NSW GOVERNMENT
Planning
Issued under the Environmental Planning and Assessment Act 1979
Approved Section 75W Modification Application
No. 2 granted on the 18 April 2017
in respect to MP 10-0016
Signed [Signature]
Sheet No. 1 of 20

PROJECT:
The Terraces
Seniors Living and Residential Aged Care Facility
74 Brown Street Paddington NSW 2021

DRAWING TITLE:
LEVEL 01 PLAN - BROWN STREET BUILDING

S75 W APPLICATION

1 Level 9 Roof Plan
Scale 1:250

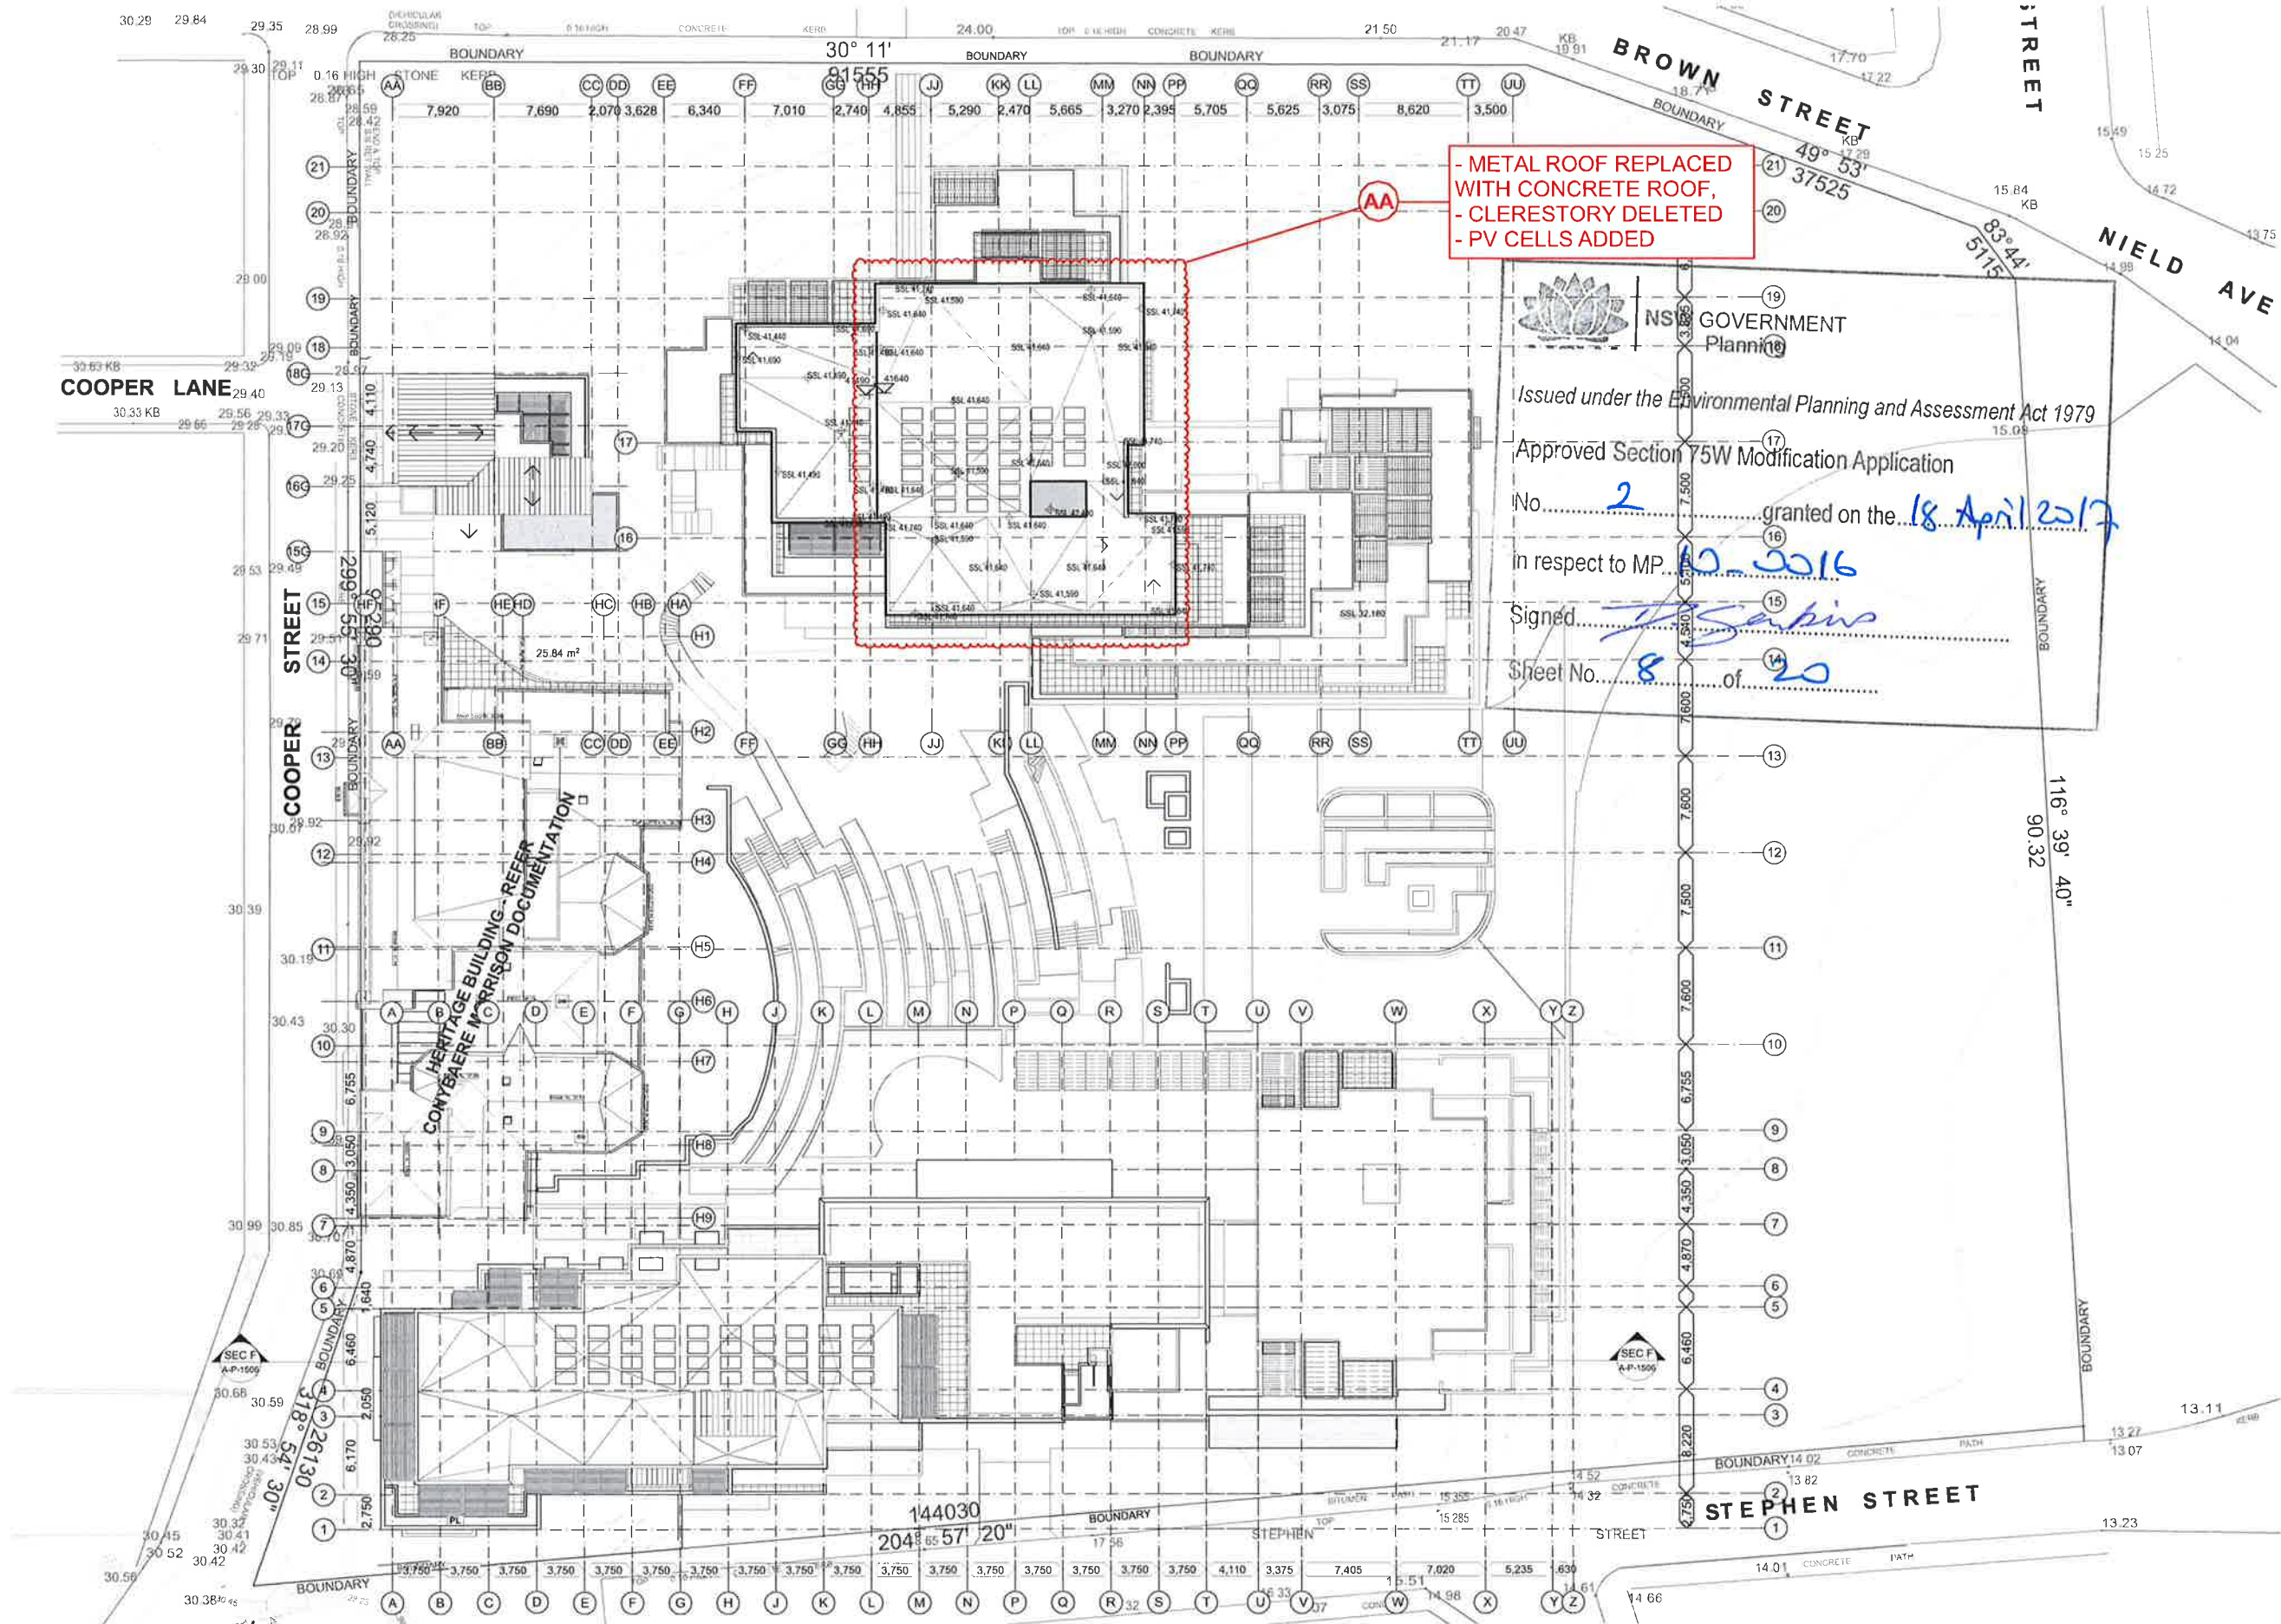
AA	16/06/16	S75 W APPLICATION BROWN ST - METAL ROOF REPLACED BROWN ST - CLERESTORY DELETED BROWN ST - PV CELLS ADDED
----	----------	---

DRAWING TITLE:
LEVEL 08- ROOF PLAN - RACF

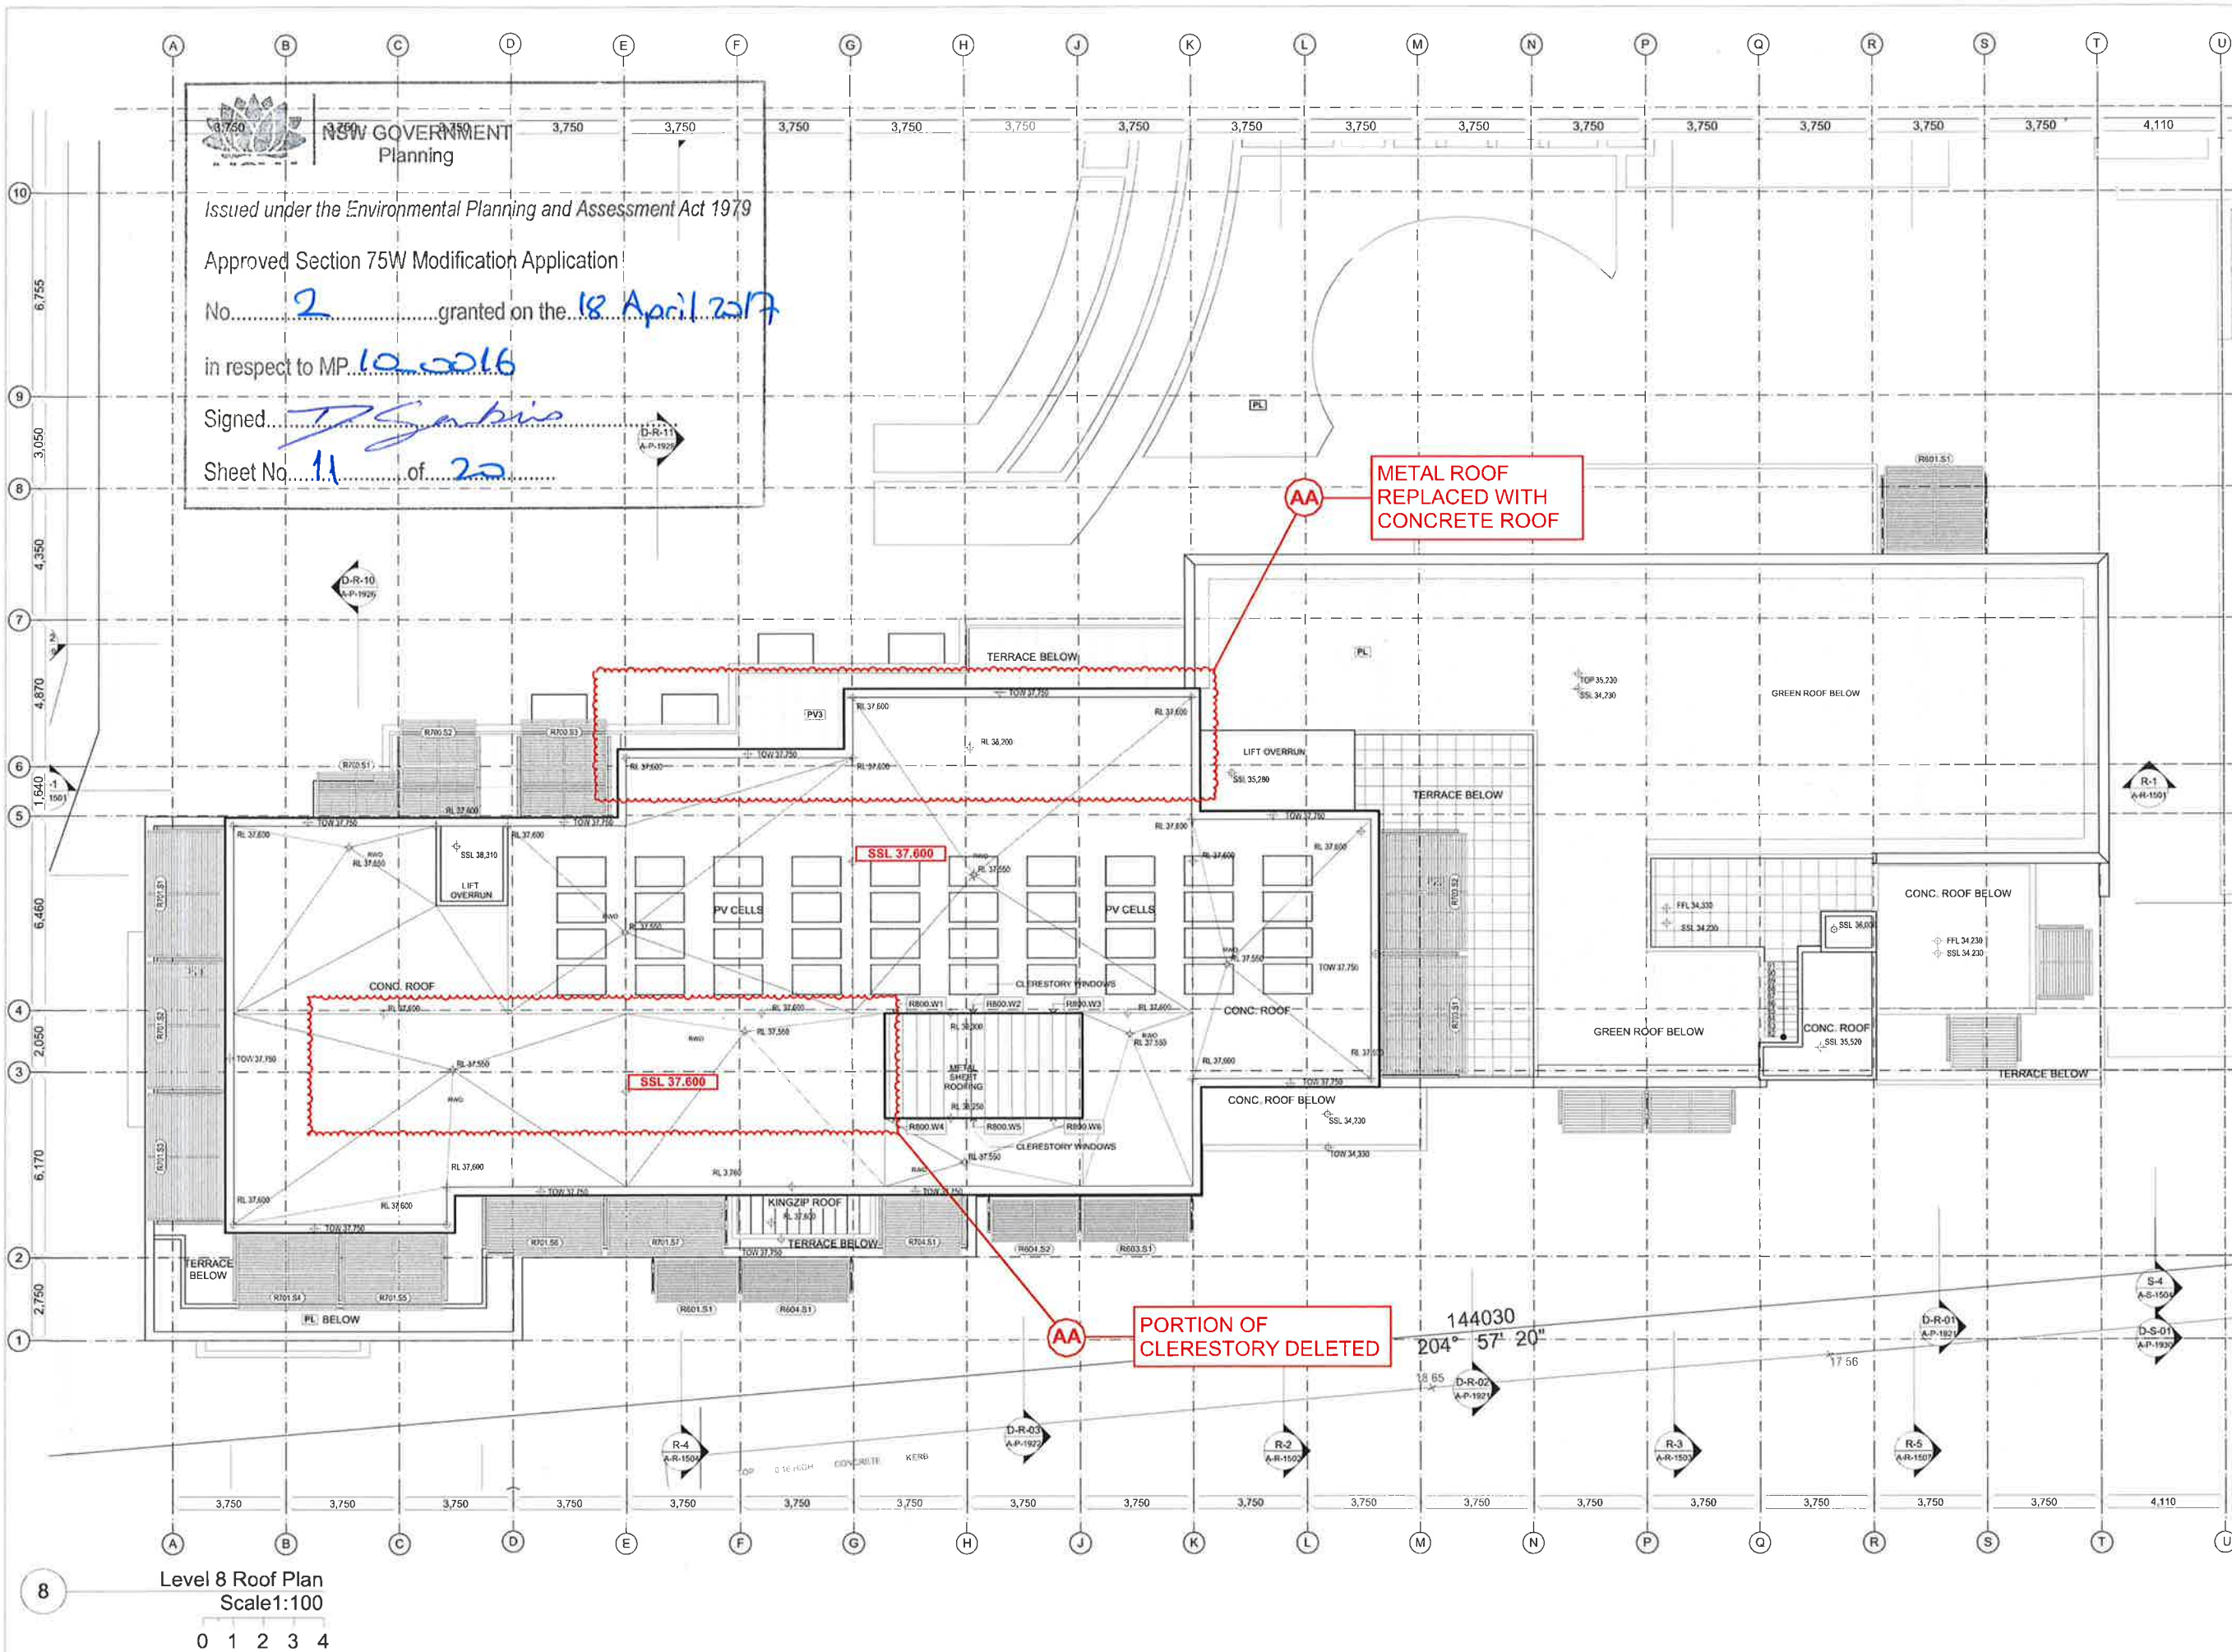
AA	16/06/18	S75 W APPLICATION
		RACF - METAL ROOF REPLACED
		RACF - PART OF CLERESTORY DELETED

Level 4
Scale 1:100
0 1 2 3 4

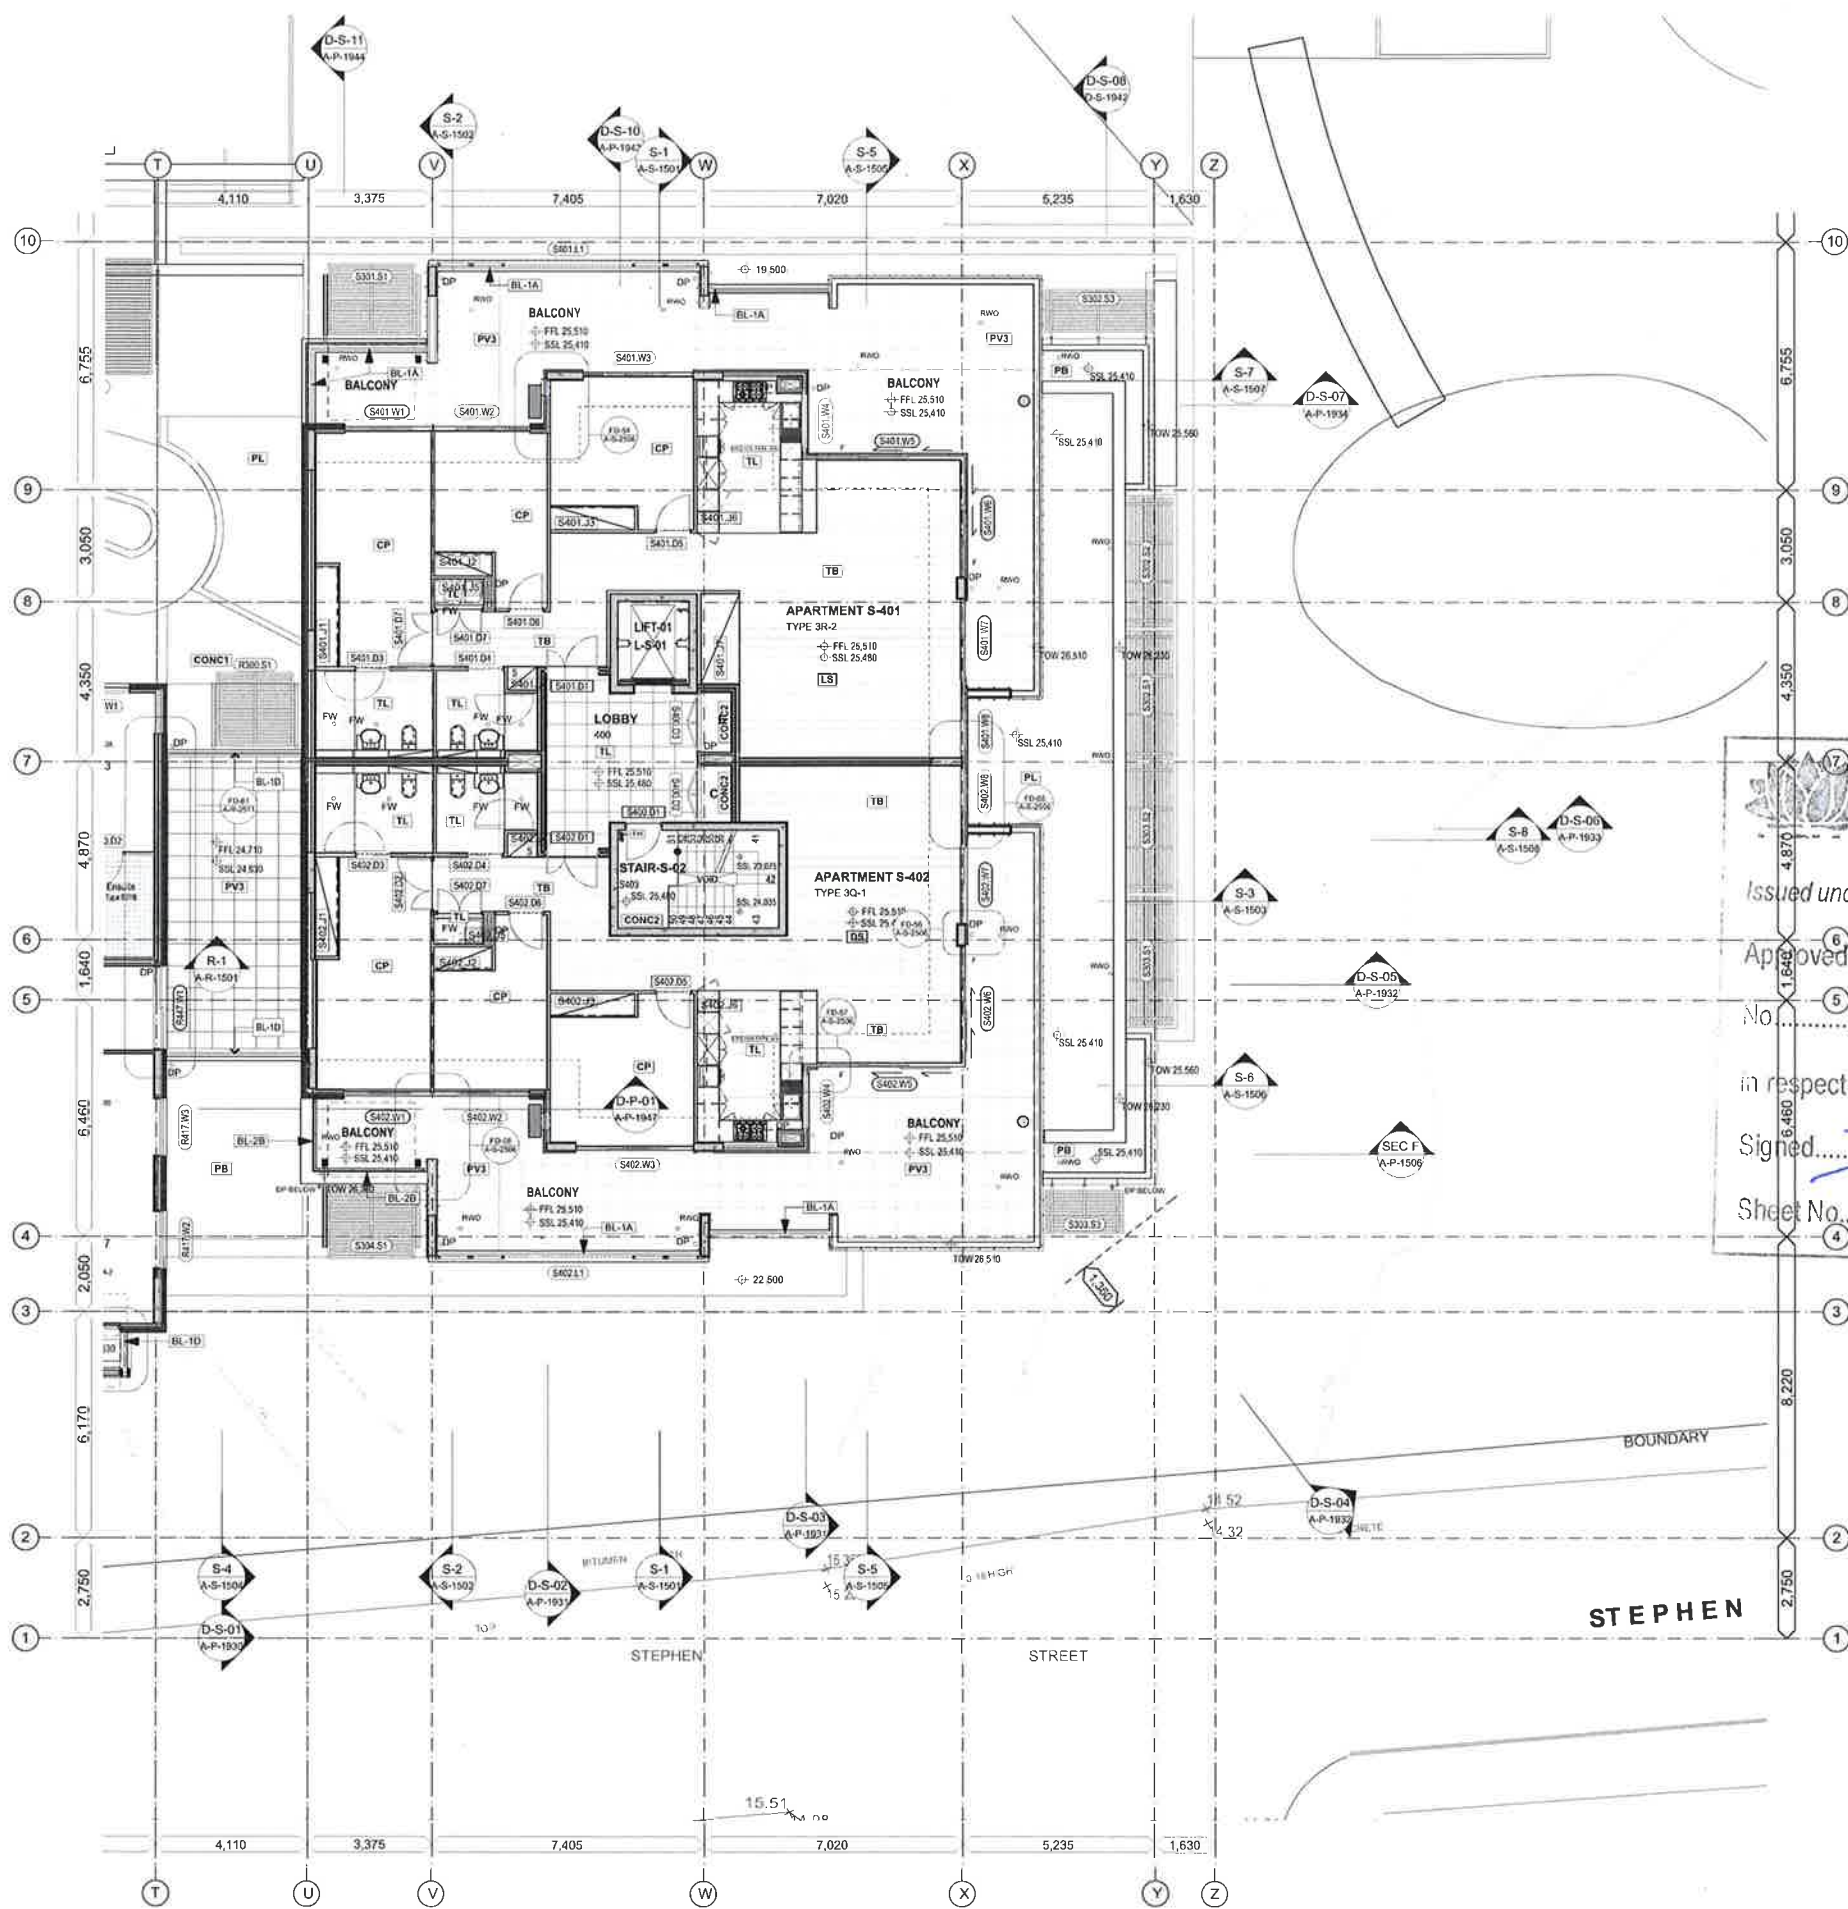
AA	18/09/16	S75 W APPLICATION STEPHEN ST - VOID DELETED ON LEVEL 3
----	----------	---
